NUCLEAR ENERGY INSTITUTE

SUBJECT: Draft Regulatory Guide DG-1081, *Alternative Radiological Source Terms for Evaluating Design Basis Accidents at Nuclear Power Reactors*, (64 Fed. Reg. 71990)
Request for Comments

PROJECT NUMBER: 689

COMMENTS ON DRAFT DG-1081 AND DRAFT SRP

Figure A-1: Measurements of Fission Gas Content in LWR Fuel Rods

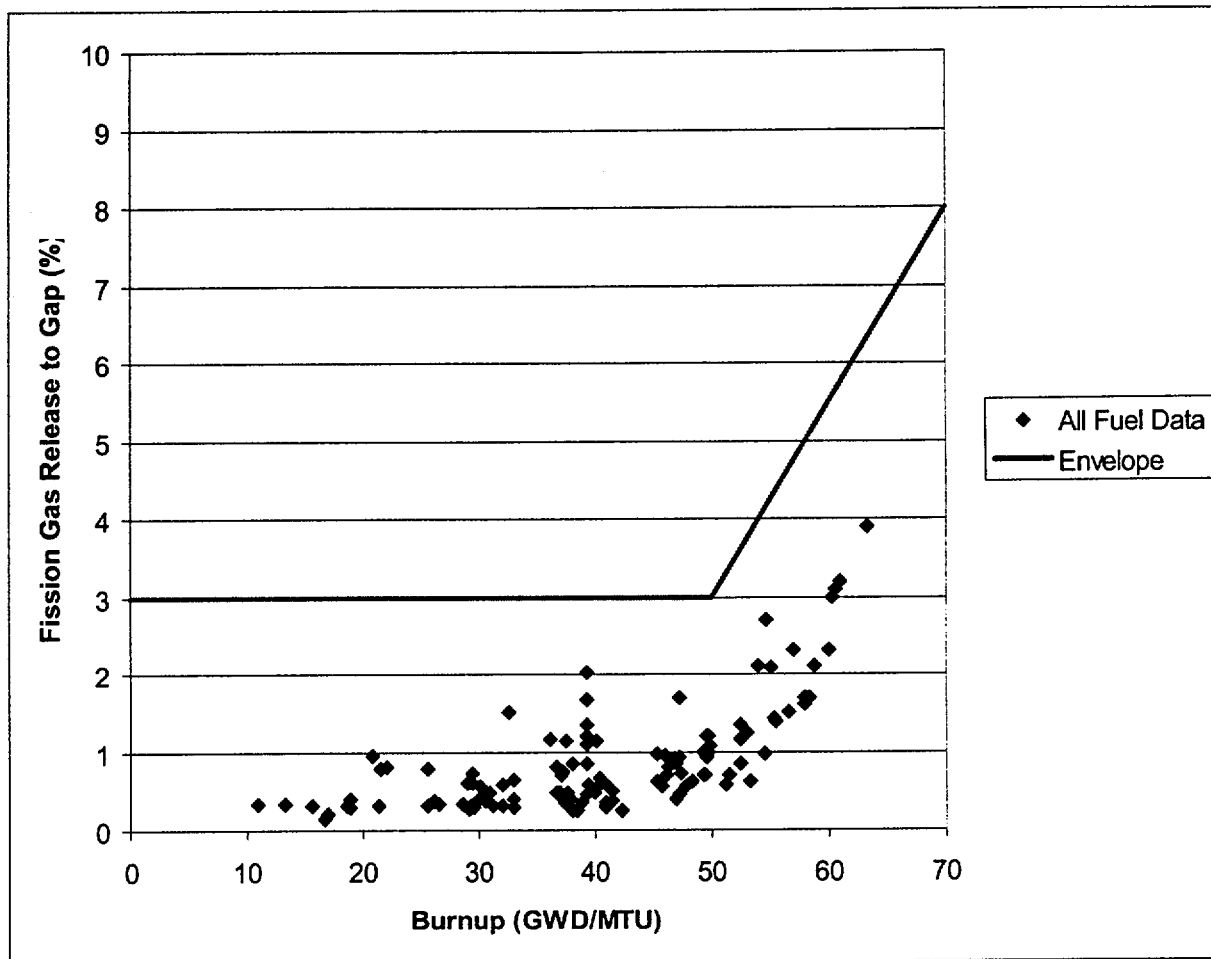
The combined data of references [2-4] show that fission product release is less than 1.0% up to a burnup of about 30,000 MWd/MTU. As the burnup increases, the gap fission product content increases to about 2% at 40,000 MWd/MTU. At about 50,000 MWD/MTU, the gap fraction increases with burnup at a rate of about 2.3% per 10,000 MWd/MTU per reference [2]. In the table below, the middle column shows an envelope of the data. The right-hand column of the table shows the industry recommended gap fractions for use in analyzing non-LOCA events. The degree of conservatism of this proposed envelope relative to the data is illustrated in Figure A-1.

A bounding envelope that industry proposes to use for the safety analyses was drawn over the data with margin added for conservatism. Industry believes that the bounding envelope is conservative for the following reasons:

- The envelope is drawn well above all data (approximately 100% margin above the mean values and 50% margin above the maximum values).
- The xenon plus krypton release percentage would be applied to iodine isotopes, which would be conservative since iodine is less volatile than xenon and krypton.

The reference data have been extrapolated to 75,000 MWd/MTU in order to encompass the burnup range which industry anticipates could be utilized over the next decade or so. This is a modest extrapolation of the above-referenced data. The 62,000 MWD/Mtu burnup data point is included in the table below since this is currently the maximum licensed burnup for operating plants.

Industry proposes that DG-1081 be changed to specify that for postulated accidents which may have damaged fuel but do not have a fuel heatup, licensees should utilize the gap fractions as a function of burnup as specified in the right-hand column of the above table.
